**Horsham Planning Scheme Amendment C81hors  
Flood protection controls**

**Panel Report**

**27 October 2023**

**Figure 4 5802 Western Highway, Dadswells Bridge**

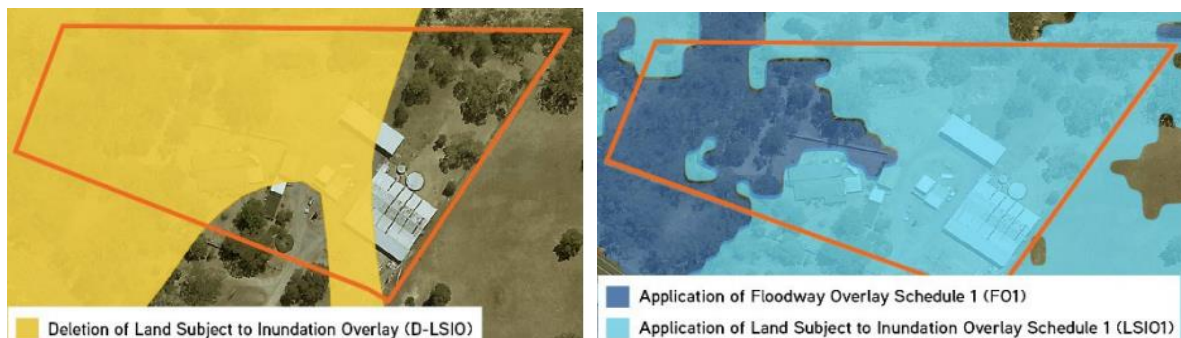
While the proposed controls do not impact existing use rights, the issue of future subdivision or further site development is more appropriately considered at the permit stage and when potential flood impacts from development can be considered in greater detail.

- The proposed application of FO1 and LSIO1 to 5802 Western Highway, Dadswells Bridge is appropriate.

**Figure 13 Proposed Zoning – Barnes Boulevard, Horsham**

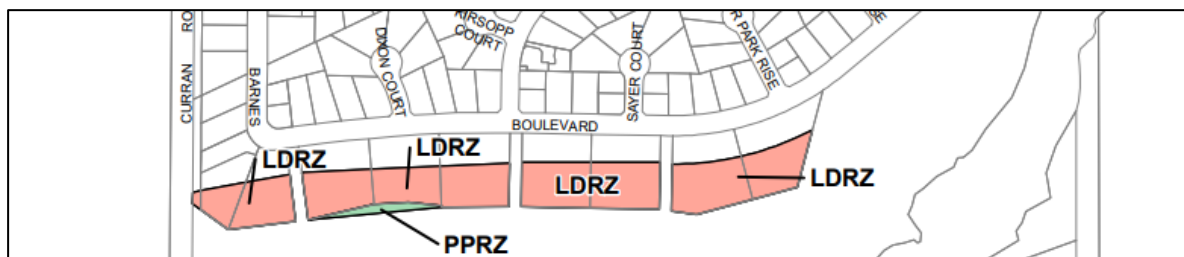
The Amendment proposes to apply the LDRZ to the entirety of the privately owned land and the PPRZ to the portion of public land (Figure 13).
